MEMORANDUM

Subj: Responses to Six Additional Questions from Mr. Severance

Critical Variables Regarding Diablo Canyon Unit 1 Embrittlement Are Not Factored by the Current 2011 PTS Evaluation

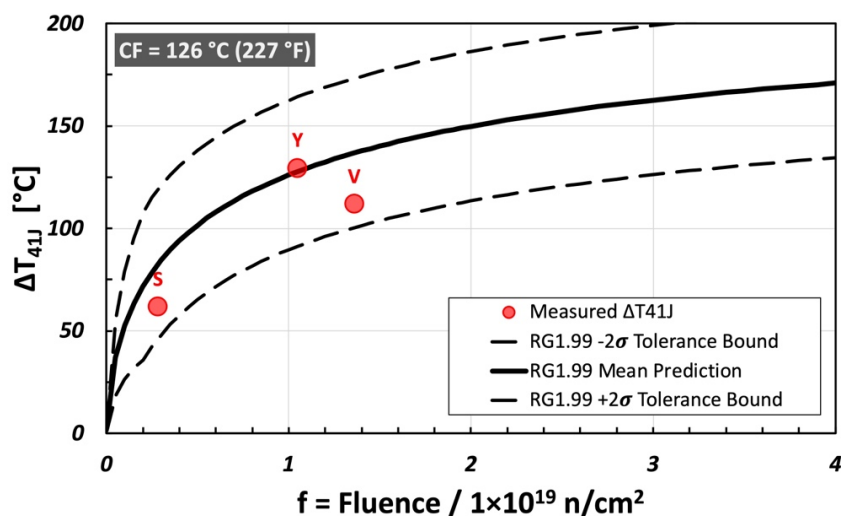
The Capsule V data was stated to be in “good agreement” with RG1.99 predictions when this did not appear to be the case based on prior publications and reporting: While the Capsule V Report states that surveillance data was in “good agreement” with RG1.99 R.2 predictions, the measured RT_{NDT} value was 135°F, with a ΔRT_{NDT} shift of 201 °F. It is important to note that shift would be 191.5°F if same $RT_{NDT(u)}$ was used as in other reports, and that the $RT_{NDT(u)}$ appears to have been changed from -56F to -67F to bring it the report RT_{NDT} values more into line with RG1.99 predictions.

Assessment of the agreement, or lack thereof, between plant-specific surveillance data and the NRC’s predictive model for ΔT_{41J} that appears in Revision 2 of Regulatory Guide 1.99 is performed by comparing the quantity measured in surveillance (ΔT_{41J}) to the NRC’s predictions of that quantity. As explained in the Part 1 report to the DCISC¹⁰, delta (Δ) values of T_{41J} are the difference between the Charpy transition temperature at 41 Joules absorbed energy (T_{41J}) measured after irradiation and that same quantity measured before irradiation. The red circles on the graph below show the values of ΔT_{41J} measured as part of the Unit 1 surveillance program (labels indicate the capsule ID). These are compared to the NRC’s prediction using RG1.99 R2; both the mean prediction (**solid black curve**) and the $\pm 2\sigma$ tolerance bounds (**dashed black curves**) are shown. All three measurements, including the measurement from Capsule V, lie well within the $\pm 2\sigma$ tolerance bounds from the NRC’s mean prediction. The characterization of these data as being in “good agreement” with the model is therefore appropriate.

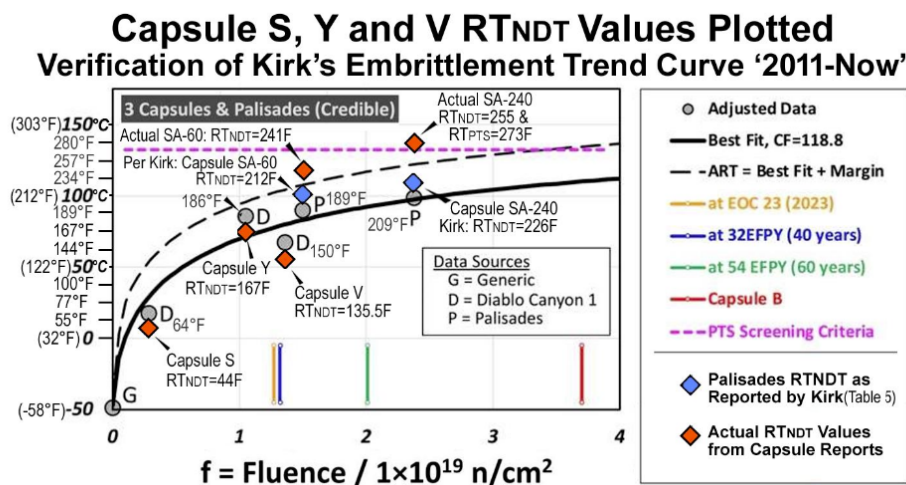
Has the DCISC noted that Dr. Kirk's Embrittlement Trend Curves (ETCs) as indicated in the Kirk Report Part 2, Figure 2 (pg. 28) appears to misrepresent actual RT_{NDT} values by as much as 46°F to 52°F?

This question is expressed in more detail in a previous communication between Mr. Severance and the DCISC.¹¹ On page 30 of his document of 1 February 2025 Mr. Severance provides the figure that appears below, which he uses to call into question the data used by Kirk in the Part 2 report (see Figure 2, bottom graphic panel of that report) in performing his evaluation of PG&E's estimation of RT_{PTS} . Mr. Severance observes that the blue and red diamonds, which he added to Kirk's figure, do not agree with Kirk's data (grey circles) for Unit 1 Capsules S, Y, and V and with data from Palisades Capsules SA-60 and SA-240. We have been able to ascertain the reason for most of the "discrepancies" noted by Mr. Severance. These reasons are described in the text following the figure.

- (1) The blue diamonds are measured values of T_{41J} that Mr. Severance took from Table 5 of the Part 2 report. He has labeled these values as " RT_{NDT} ," which is incorrect; T_{41J} and RT_{NDT} are not the same. T_{41J} is a measured value of Charpy transition temperature. Conversely, RT_{NDT} is determined by adding the unirradiated value of RT_{NDT} (as reported in the Part 2 report, Diablo Canyon uses a generic value of

- (2) Likewise, the red diamonds plotted for Unit 1 Capsules S, Y, and V are measured values of T_{41J} taken from the respective surveillance capsule reports. As just explained in (1), values of T_{41J} are not the same as values of RT_{NDT} .

- (3) We have been unable to determine the source for the red diamond values of RT_{NDT} on this figure that Mr. Severance claims are associated with the Palisades capsules SA-60 and SA-240 ($241\text{ }^{\circ}\text{F}$ and 255°F , respectively). We have reviewed both capsule reports^{13,14} as well as a report on a PTS evaluation of the Palisades¹⁵ plant quoted by Mr. Severance as his Citation #50 and have been unable to determine the source of these values.

- (4) The RT_{PTS} value of $273\text{ }^{\circ}\text{F}$ that Mr. Severance associates with the red diamond for Palisades Capsule SA-240 appears in a PTS evaluation for Palisades (footnote 19) and in a table included in Mr. Severance's document (see Table 10 on page 31) that is copied from the Palisades PTS report (see again footnote 15). Placing a calculated RT_{PTS} value for Palisades on a data plot for Diablo Canyon Unit 1 is inappropriate. While the plants share sister data for weld wire heat 27204, the RT_{PTS} values themselves are plant-specific and cannot be compared between plants. Additionally, Table 10 on Mr. Severance's page 31 indicates that the RT_{PTS} value of $273\text{ }^{\circ}\text{F}$ corresponds to a fluence factor of 1.322 or, equivalently, a fluence of $3.45 \times 10^{19}\text{ n/cm}^2$. However, on the plot copied on the previous page the red diamond for Capsule SA-240 appears at a fluence of $2.39 \times 10^{19}\text{ n/cm}^2$.

In summary, there is no misrepresentation of the RT_{NDT} value for Diablo Canyon Unit 1 in any of Kirk's reports to the DCISC. The discrepancies arise mostly because Mr. Severance is comparing T_{41J} (Charpy transition temperature) values to RT_{NDT} . As explained here, RT_{NDT} and T_{41J} are not the same. Other sources of discrepancy are Mr. Severance's comparison of RT_{PTS} estimates for the Palisades plant to T_{41J} measurements, which is also inappropriate.
